DOCUMENTATION TRANSMITTAL

Documentation Description: Nonconformance Reports: C-03719-V  
C-03727-V

NONCONFORMANCE REPORT

16 NCR NO.	C-03727-V	
17 DATE ISSUED	5-12-84	18 REV 0
19	PAGE 1 OF 23 <sup>W/5-12-84</sup>

Ref. C-224 rev. 7 & FSK-C-113 SH-18 rev. 3

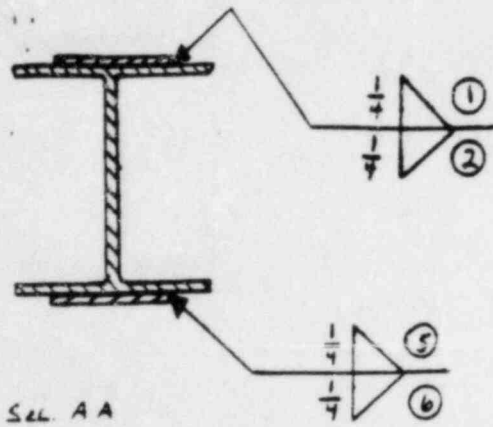
① & ② D11A Embedded in Concrete

⑤ WELDER ID I-27 \* MEASUREMENTS WITH RESPECT TO NORTH END OF R

- # 1 1ST FT. INSUFFICIENT THRDT 9/32" LONG
- # 2 2ND FT. UNDERSIZE LEG
- # 3 3RD FT. UNDERSIZE LEG
- # 4 4TH FT. UNDERSIZE LEG

EXCEEDS TOTAL LENGTH PERCENTAGE CRITERIA

⑥ WELDER ID I-40

\* MEASUREMENTS WITH RESPECT TO SOUTH END OF R

- # 5 3RD FT. OVERSIZE LEG 1/2" ACTUAL FOR 1/4"
- # 6 4TH FT. OVERSIZE LEG 1/2" ACTUAL FOR 1/4"
- # 7 5TH FT. OVERSIZE LEG 1/2" ACTUAL FOR 1/4"
- # 8 6TH FT. OVERSIZE LEG 1/2" ACTUAL FOR 1/4"
- # 9 7TH FT. OVERSIZE LEG 1/2" ACTUAL FOR 1/4"
- # 10 8TH FT. OVERSIZE LEG 1/2" ACTUAL FOR 1/4"

- # 11 3RD FT. BASE METAL DEFECT IN R
- # 12 1/8" DEEP, 1/4" LONG, 9/16" FROM THE
- # 13 EDGE OF THE R

20B4R

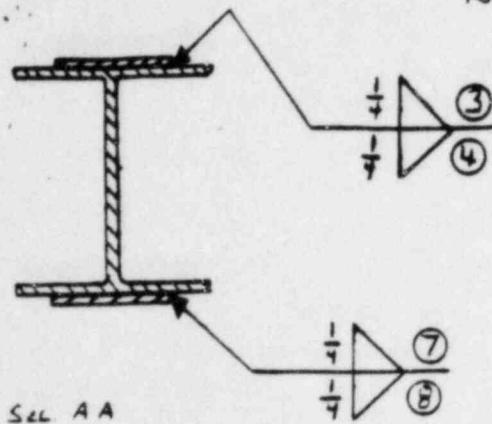
③, ④ D11A Embedded in Concrete

⑦ welder ID, I-27, I-19, I-41

D11A 1<sup>st</sup> 7' Insufficient space to perform inspections

#11 10<sup>th</sup> ft Undercut > 1/32" exceeding 2" in 12"

#7 15<sup>th</sup> ft Over size leg 1/2" actual size for 1"

#1 Crack in Base metal adjacent to toe of weld @ ≈ 14" from start point.

⑧ welder ID I-19, I-27

#11 3<sup>rd</sup> ft Undercut > 1/32" exceeds length tolerance.

#11 12<sup>th</sup> ft Undercut > 1/16" for 3/16"

Joint # 11

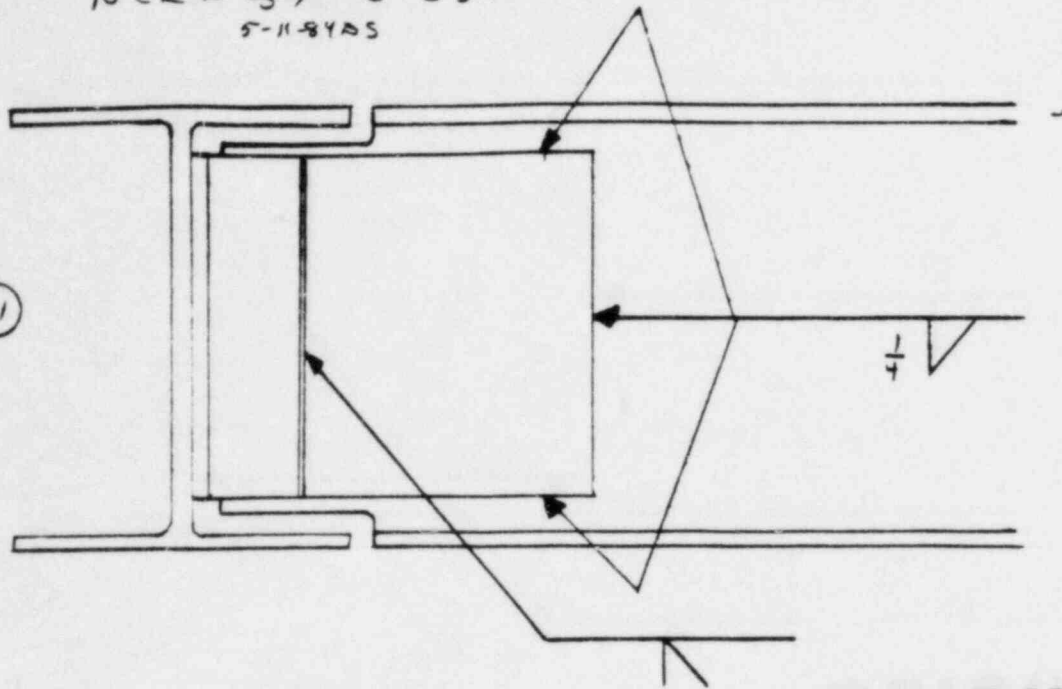
South Side ID I-27

Due to limited space unable to measure rest of weld.

#10 Full Pen. Flush contour

North Side ID I-27

#10 Full Pen. under fill (concave contour)

Joint # 12

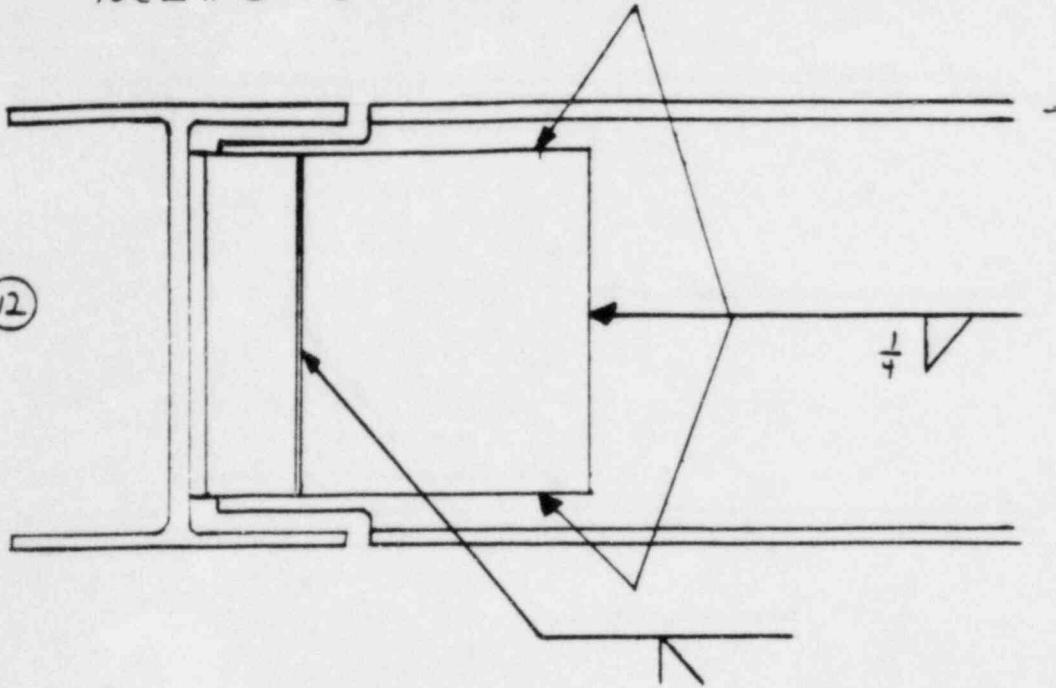
#10 Full Pen Flush Contour  
ID I-24

Fillets ID I-40

Consumed Edge of Base Metal

#7 1 leg Oversize 1/2" actual

North Side ID I-24

#10 Full Pen Flush Contour

Fillets Consumed Edge of Base Metal

#7 1 leg oversize 5/8" actual (all welds)

Joint # (14)

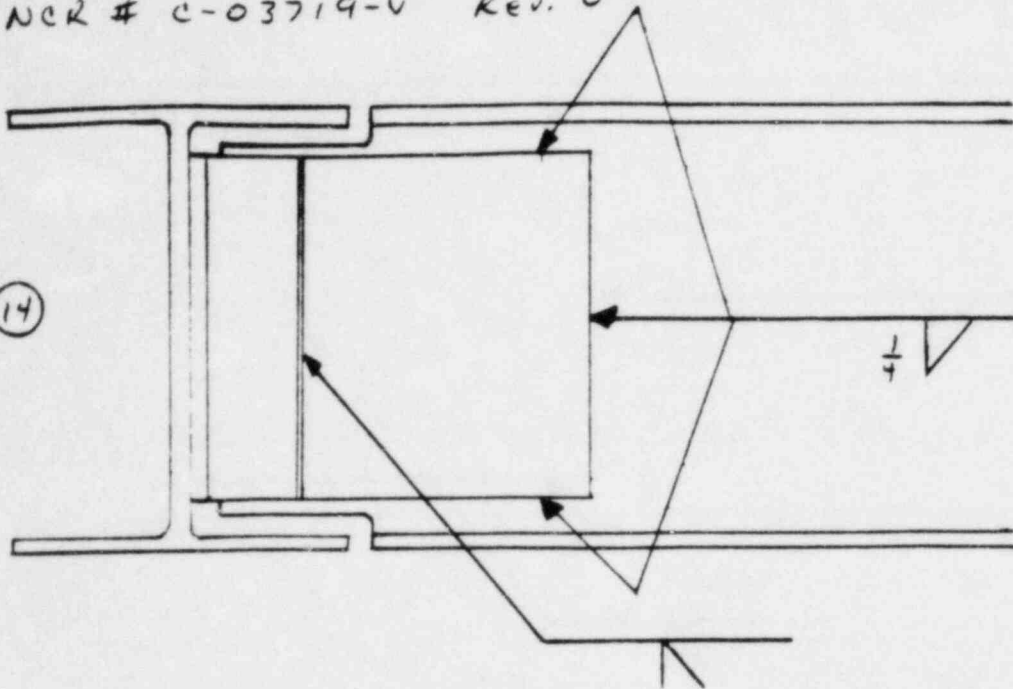
South Side ID I-32

#10 Full Pen. Flush Contour

Fillets Top Fillet unable to measure. Leg size due to limited space.

North Side ID I-32

#10 Full Pen. Flush Contour

Joint # 15

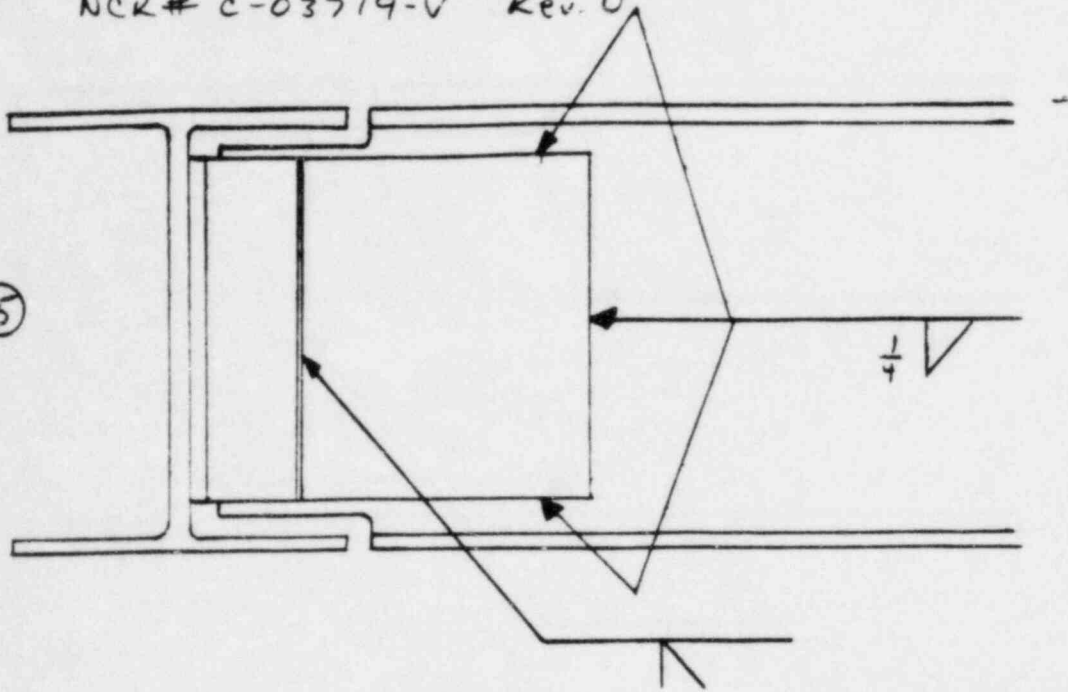
\*4 #10 Full Pen. Slightly Concave, No welder ID

Fillets ID I-24

Consumed Edge of Base Metal

#8 1 leg oversize 5/8" + actual (all Fillets)

North Side ID I-24

#10 Full Pen Flush to Slightly Concave Contour

Fillets Top Fillet consumed Edge of Base Metal

#8 Vert. & Bot. Fillets 1 leg Oversize 5/8" + Actual

Joint # (17)

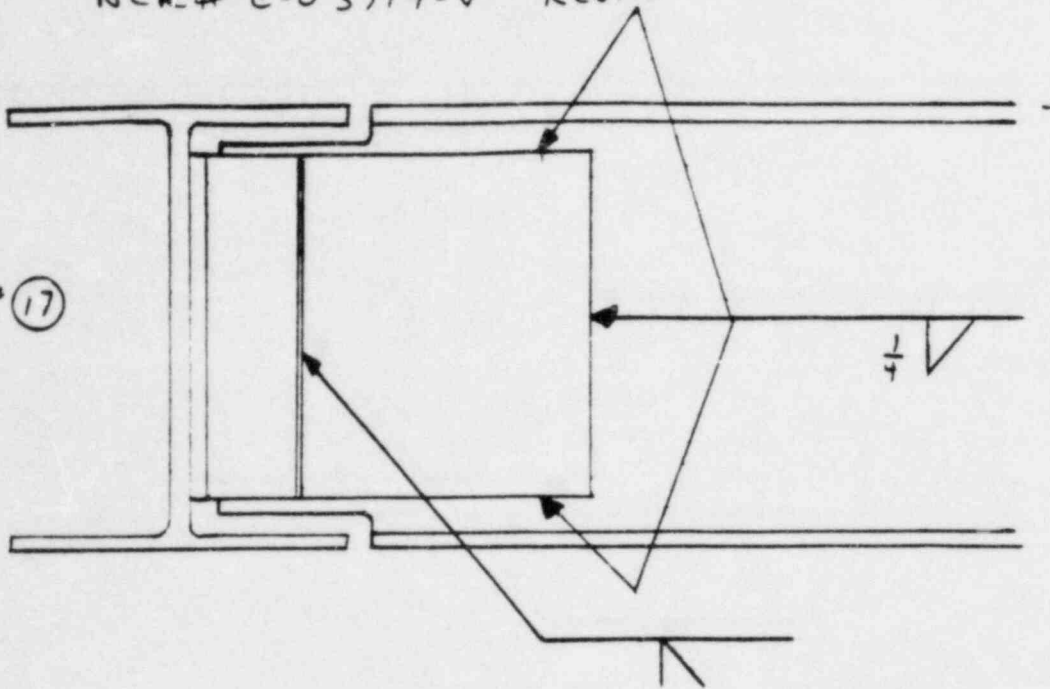
South Side ID I-33<sup>ms 1718</sup> 17

Fillets Consumed Edge of Base Metal

#8 1 leg Oversize 5/8" actual (all Fillets)

North Side ID I-33

#10 Full Pen. Slightly Concave

Fillets Consumed Edge of Base Metal

#8 1 leg Oversize 5/8" actual (all Fillets)

Ref. FSK-L-113 sht. 1B NO SCALE

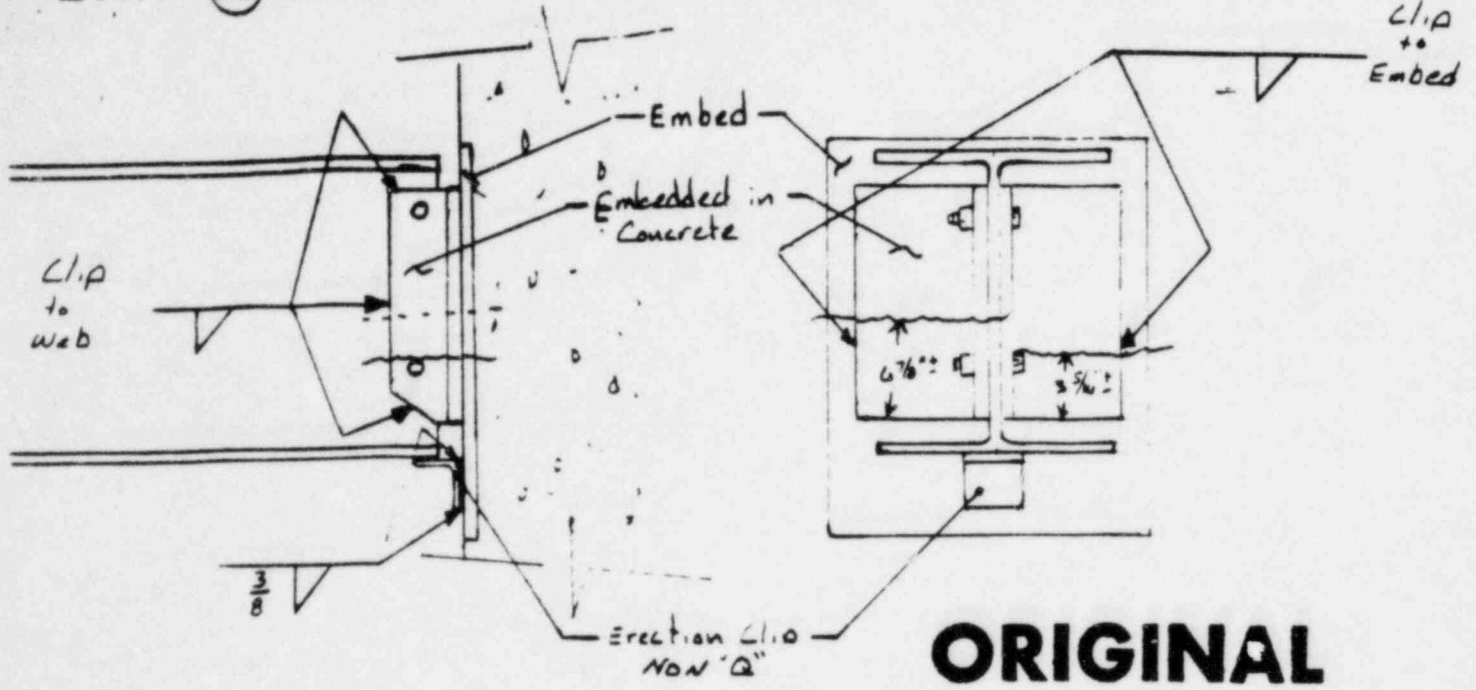
#5 No Bottom End

East Side Inspected 3 5/8" of weld remainder DIIA

#5 No Botto return

Joint #21 DIIA unable to Inspect Due to Congestion of conduit & cable trays.

Joint # 23

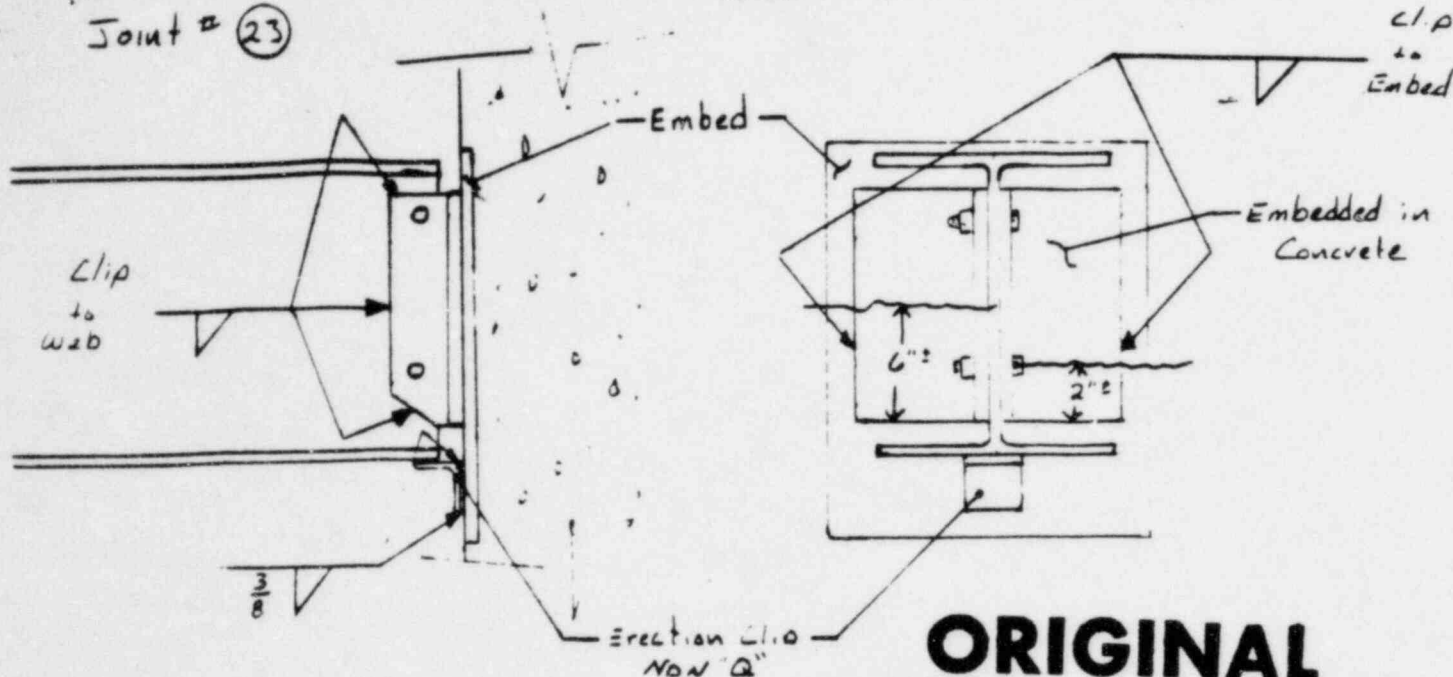
Clip to Web D11A (Embedded in concrete)

Clip to Embed Inspected 2" : Remainder D11A

Clip to Web D. #3. Weld. #2 #7  
 1/16" Undersize 40% of weld length  
 Slag along toe of weld

Clip to Embed Inspected 6" : Remainder D11A

#2 Slag along Toe of Weld (End Return)

Joint #24

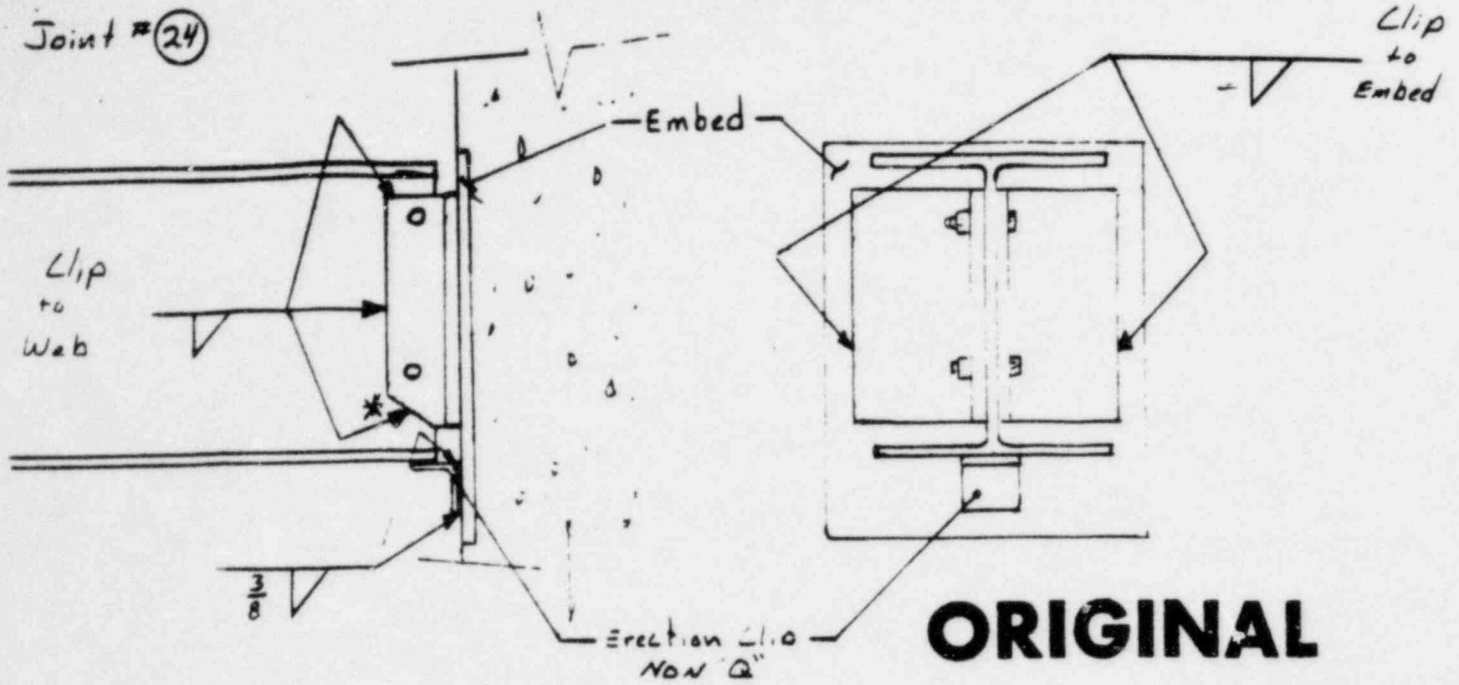
West Side Welder ID I-17

#2 Clip to web slag along toe of Diag. Weld

Clip to Web & Clip to Embed weld sizes D11A  
Insufficient access to perform measurements

East Side Welder ID I-17

Clip to Web Diag. Weld \*

#7 Insufficient Throat & Both legs Undersize 1/8" 100%  
#2 Slag along toe of weld

Clip to Embed Bottom End return Undersize leg

#2 Slag along toe of weld  
#7

Joint #26

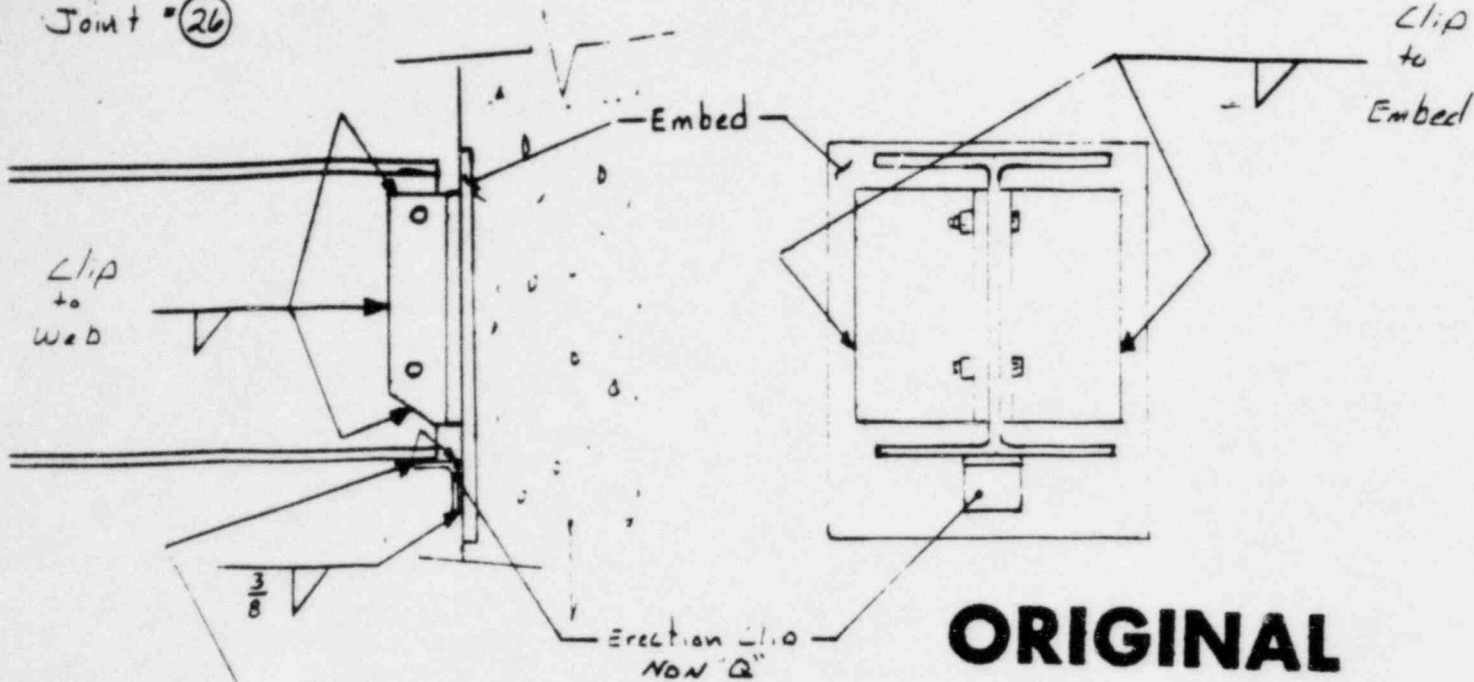
Tack weld erection clip to Flange of Beam cracked

West Side welder ID I-41

#5 No Bottom End return

Diag. weld  $\frac{5}{8}$  consumed Edge of Base metal

East Side welder ID I-41

#5 No Bottom End Return

#9 Top End Return  $\frac{1}{2}$ " in length

Joint = (28)

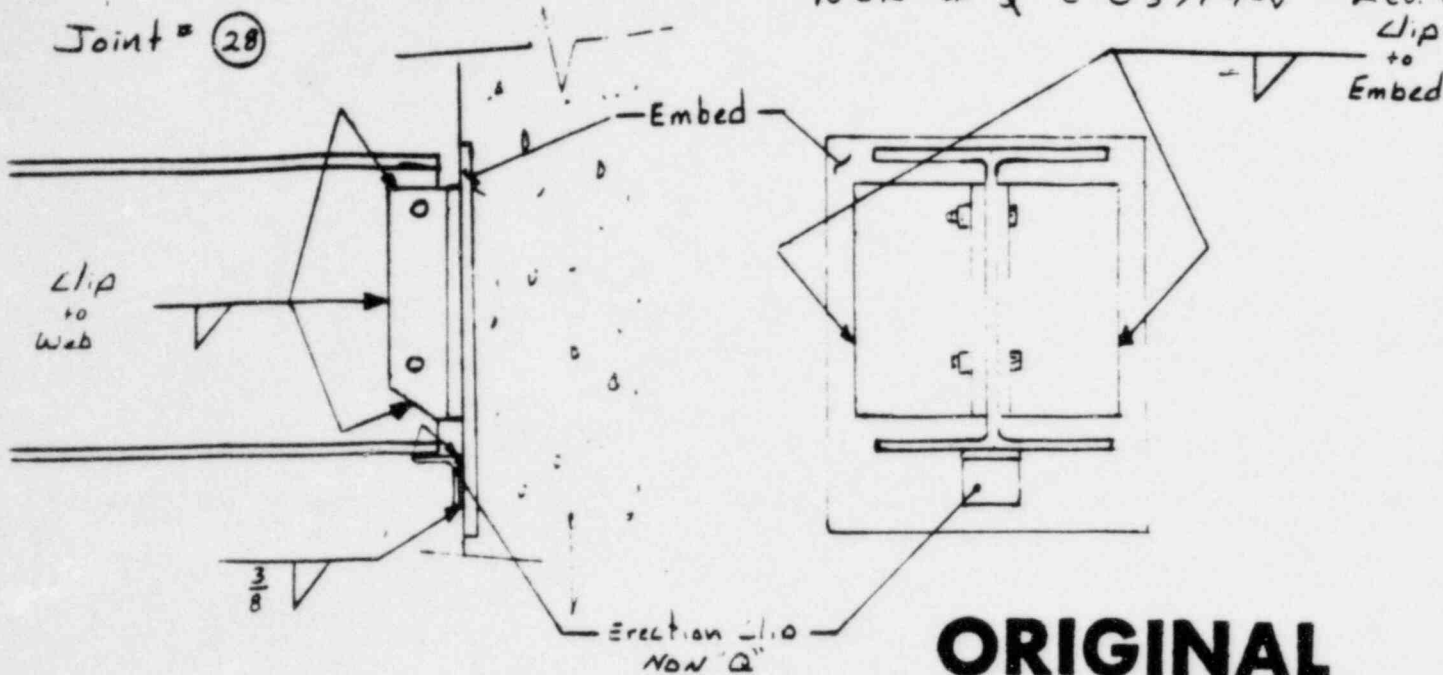
East Side No ID #4

Clip to Embed  
No Bottom End Return #5

Bottom Diag. No Weld #5

Vert. Weld undersize leg #7 #11 #9  
undercut > 1/16 = 3/32  
weld does not extend full length of plate

West Side No ID #4

Clip to Embed  
#5 No Bottom End return  
#7 Top End return undersize 1/4" actual size 100%  
#8 Insufficient Throat 100%  
#8 Vert. Weld oversize leg 5/8" actual 1" long

Vert. Weld Slag along toe of weld #2  
undersize for 1/2" tongue #7  
undersize #11  
undercut > 1/16"

Diag. Insufficient Throat for 1/4"  
Undercut 3/32"

JOINT # (50)

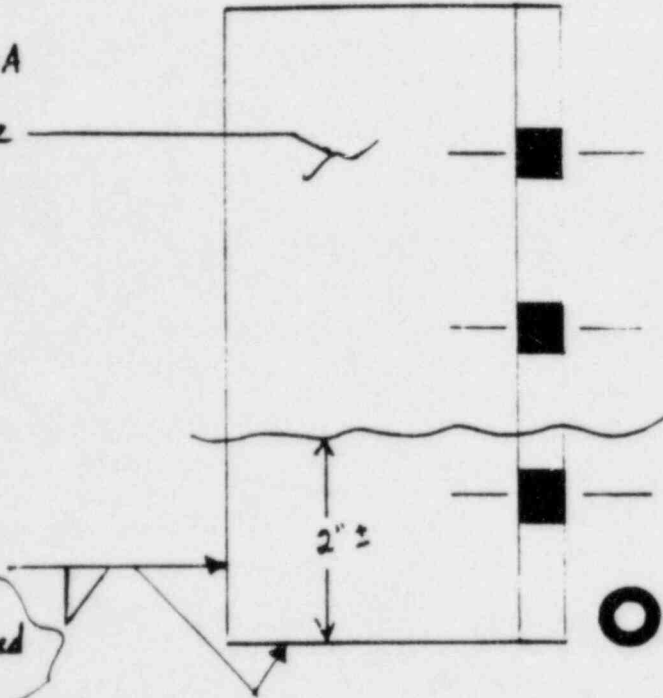
Consumed Edge  
#3 welded Vert. Down  
#6 1 Leg 5/8 3/8 required

Ref. FSX-C-113 slt. 11/18, Am 2185N

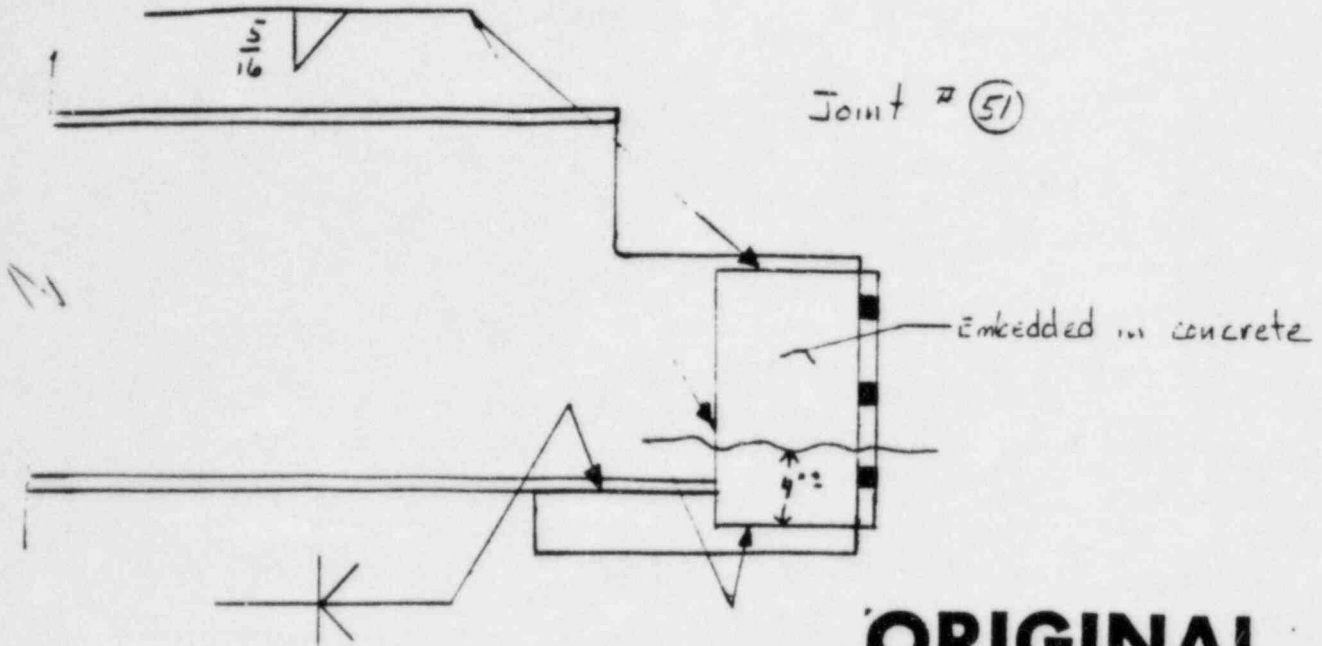
#5 Full Pen ID I-27  
 5/16 x 7/16 Fillet Not shown on Dwg.

Consumed Edge of Base Metal

#5 Full Pen No welder ID  
 5/16 x 7/16 Fillet Not shown on Dwg.

Consumed Edge of Base metal

#3 Welded Vert. Down.
